Topics of concern (clause 52)

- Jitter (definition and) measurement
- Test patterns
- Calibration of Stressed Rx sensitivity eye
- *Generally, we don't have a complete standard if we specify key interoperability parameters in ways that cannot be measured*

Figure 52-14—Required characteristics of the conformance test signal at TP3

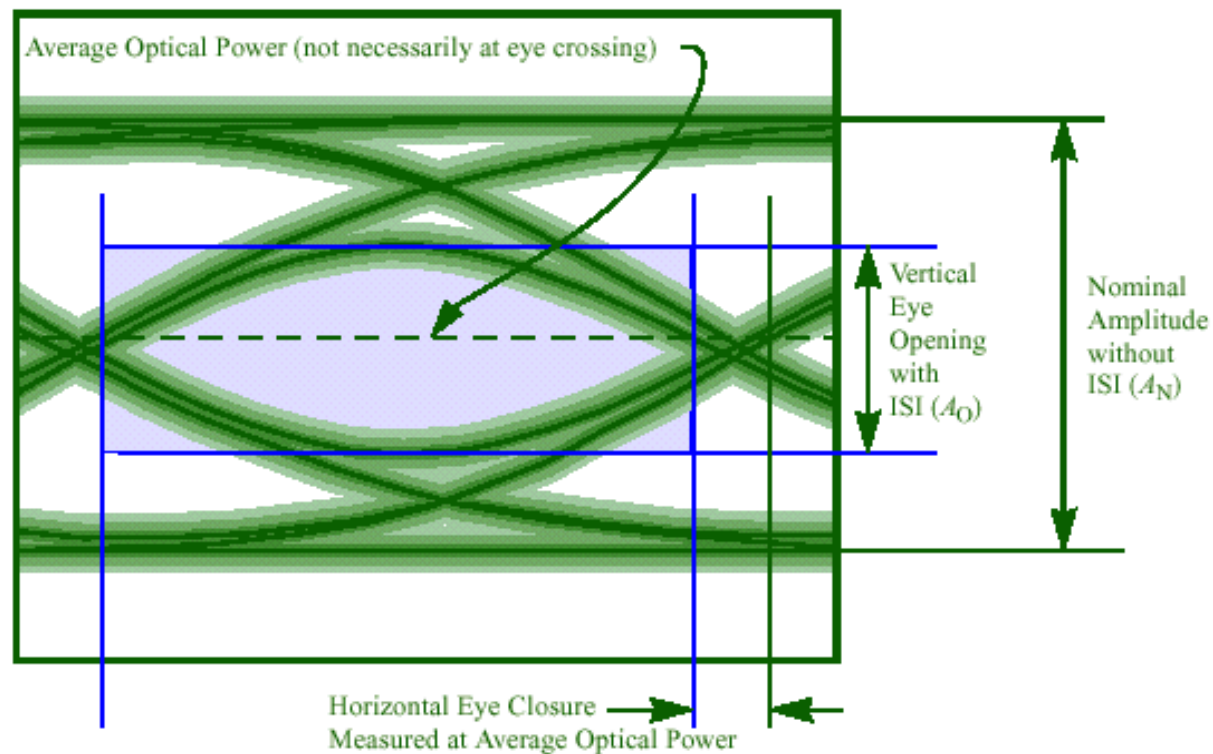
- Per Figure 52-14, cal requires good observability for DCD and VECP
- However, actual eye will not be so distinct
 - Golden PLL will add jitter domain version of baseline wander
 - Baseline wander in test source?
 - Under-sampling of lower probability events with long patterns
 - O/E and scope noises

Real situation not like this...
